NMA PP-15249897

65 Eastcourt Avenue - Porch

Porch Amendments

25/09/2026

Porch Changes

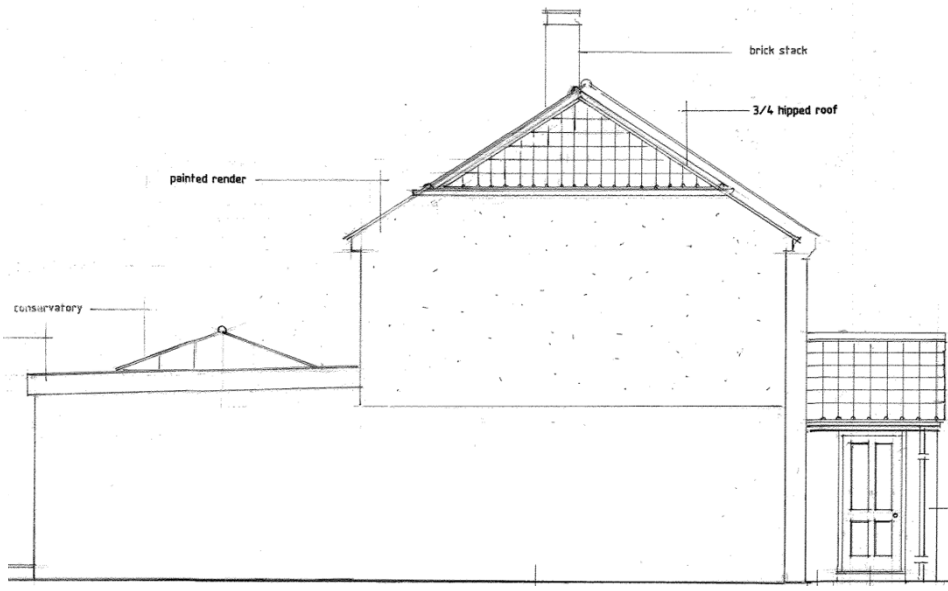
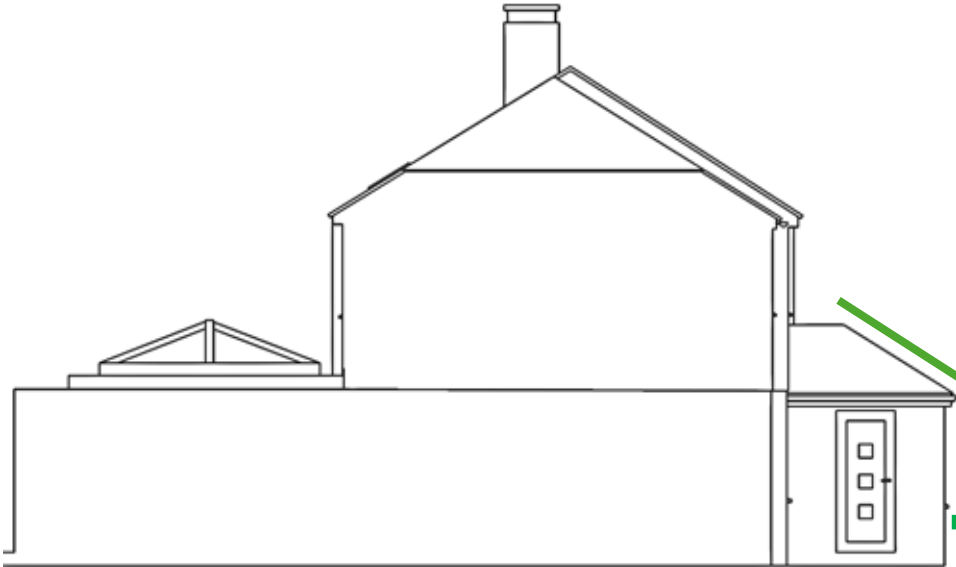
- Approved as part of planning application 252886
- Narrow entrance, proportionally like entering side of a front facing porch.
- Required two gutter downpipes.
- Requires external door internally to hall.

- 0.4m Additional Depth
- Hipped roof
- Combined gutter arrangement with a single downpipe on the right-hand side
- Cavity wall insulation to meet Part L insulation requirements of building regs and removal of internal 'external' door.

→ 0.4m

Porch Changes – Overlaid Comparison

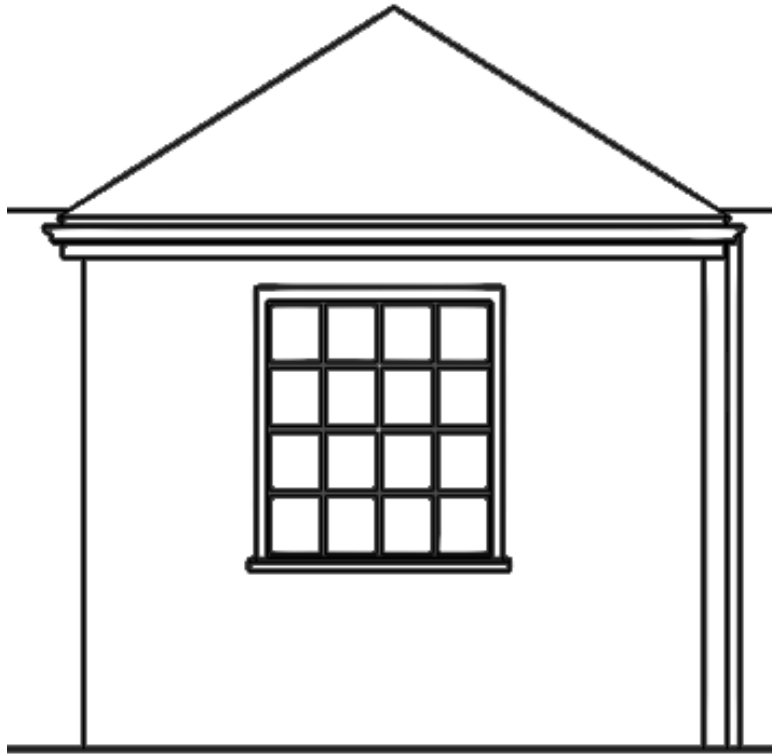
Front Aspect – No Change
Gutter and hipped front only

Side Aspect
Increase in depth offset by hipped roof
for comparable overall visual mass

Whilst there is a small increase in depth, the visual mass is offset by the hipped roof and due to the substantial set back from both road and boundary an NMA seemed a viable route for the the amendment. Additionally note that the size change is very small in proportion to the overall planning approval and with no change to width we have not move closer to any neighbouring boundaries.

Porch Changes – Combined U-Gutter + Single Down Pipe

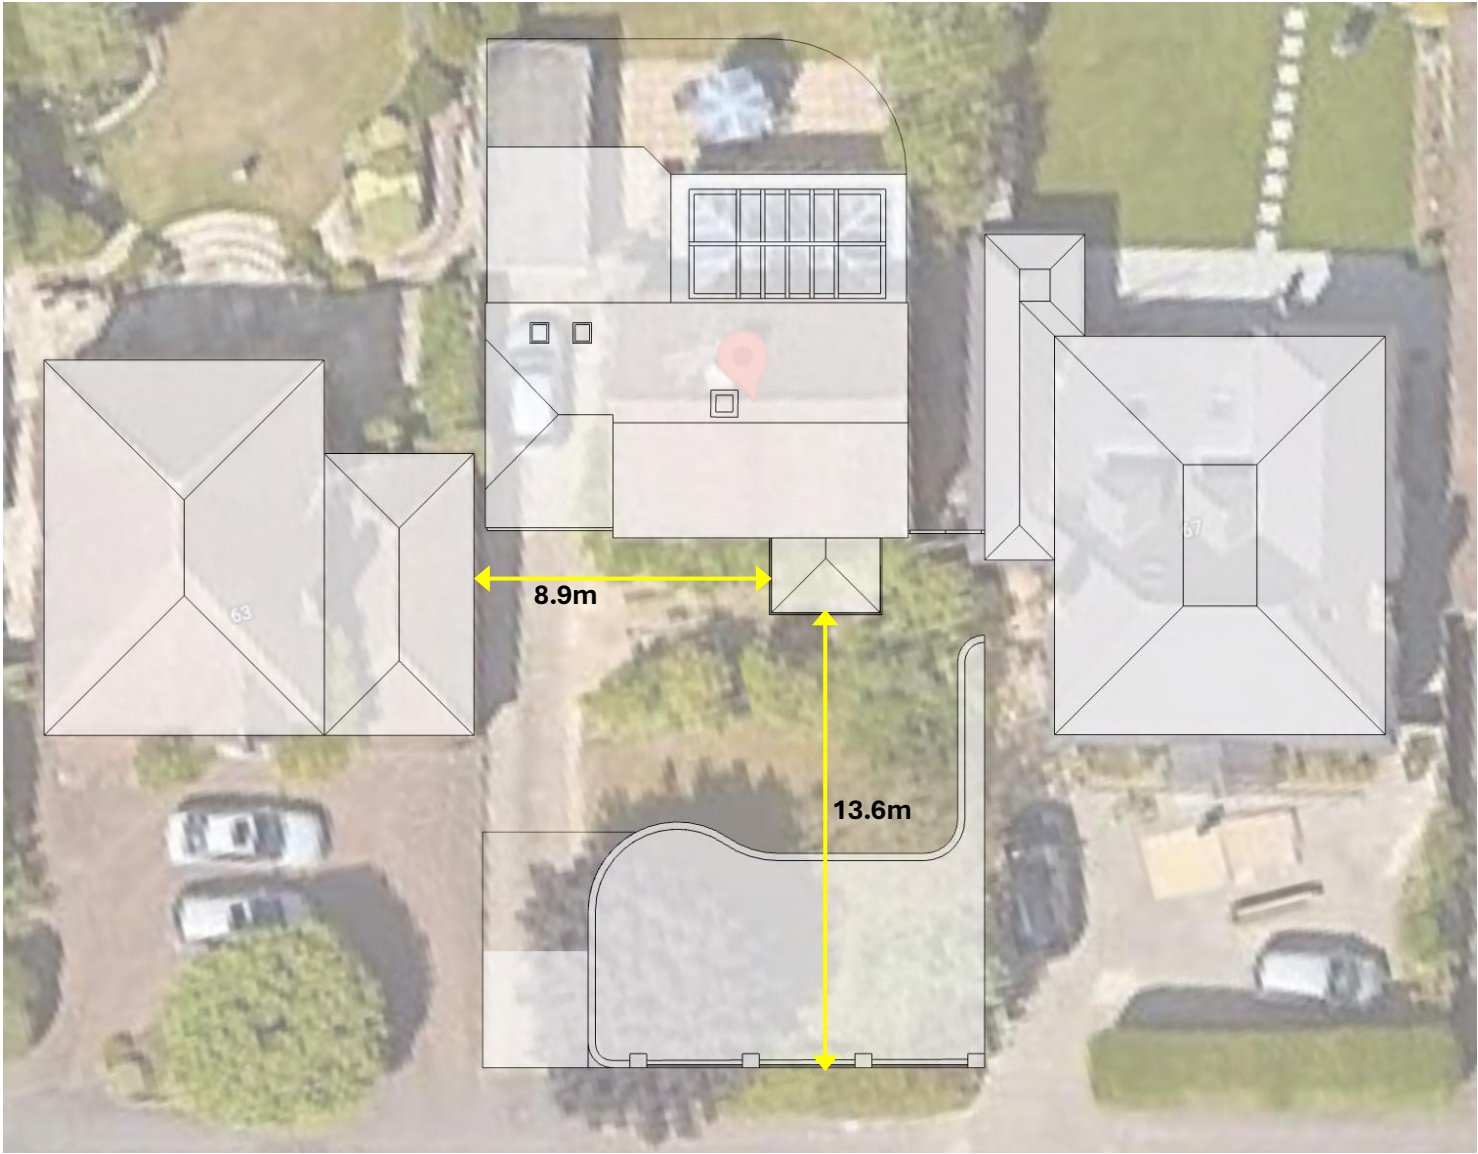
SINGLE DOWN PIPE

- Combined gutter arrangement with a single downpipe on the right-hand side
- Same soakaway location in front garden – no change.
